Title:	Husky 3 Foam Upgrades			
Number:	PB_757	Release Date:	12/02/2025	
Revision Number:	Not Applicable	Revision Date:	Not Applicable	
Chassis Type:	Custom Chassis			
Component Description:	Upgraded Husky 3 Display/Control Head, Condensed Manifold, Foam Pump, and Power Unit

We are excited to share several updates to our Husky 3 foam system. This has been a collaboration of your feedback to improve durability, manage parts obsolescence along with industry changes with foam application.

Display/Control Head:

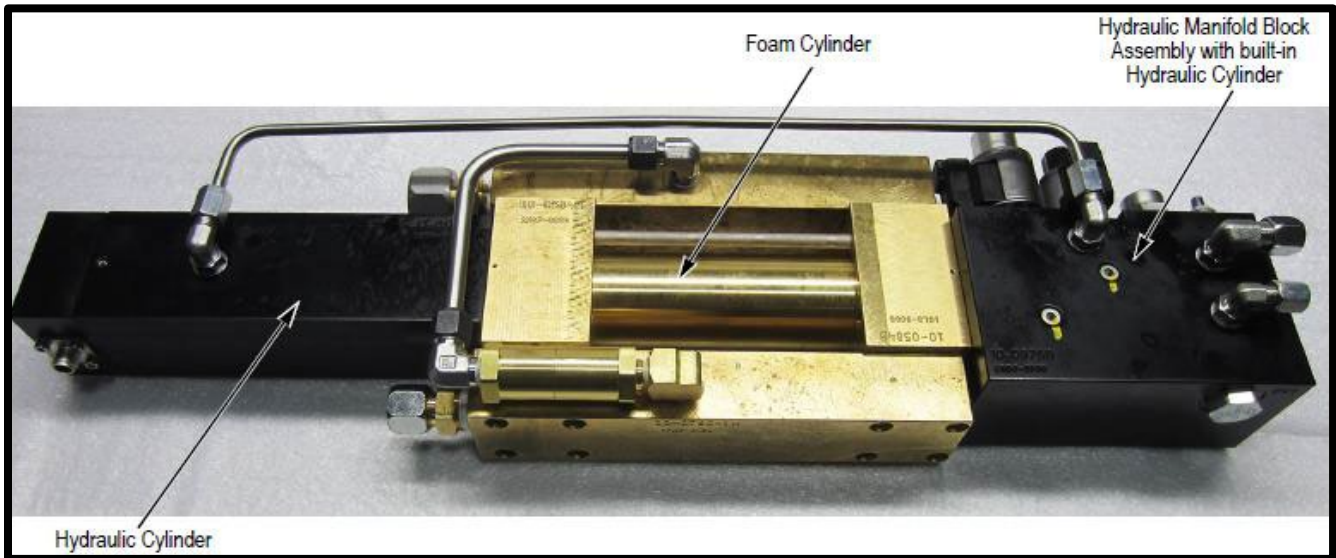
- The current Husky 3 display uses components that are becoming obsolete. We are working with our supplier on a new version that keeps the existing features and simple operation.
- New features will be added over time as we continue to develop the control system.
- The new display will be backwards compatible using a conversion harness and mounting plate.
- **Planned implementation in the first quarter of 2026.**

Retrofit Parts	
PN	Description
4794684	Adapter, Plate, H3, Retrofit
4773771-0001	Display, H3, Gen 2
4773773-0001	Controller, H3, Gen 2
4773775	Harness, H3 Foam, Retrofit
4773776	Harness, H3, Adapter, Display
